Errata Sheet

Product Family: Productivity 3000

Manual Number: P3-USER-M

Correction to Chapter 4: Specialty Modules

P3-SCM Serial Communications Module

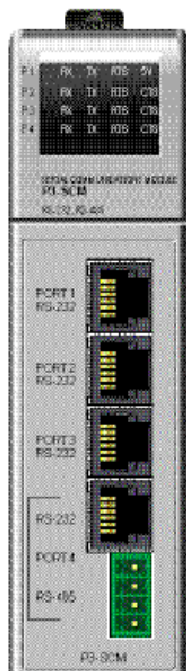
Page 17 contains the specification tables for the P3-SCM module. In the General Specifications table the value for "Modules per Group" was listed as 22 Max. which is incorrect. The correct value for this entry is 11 Max.
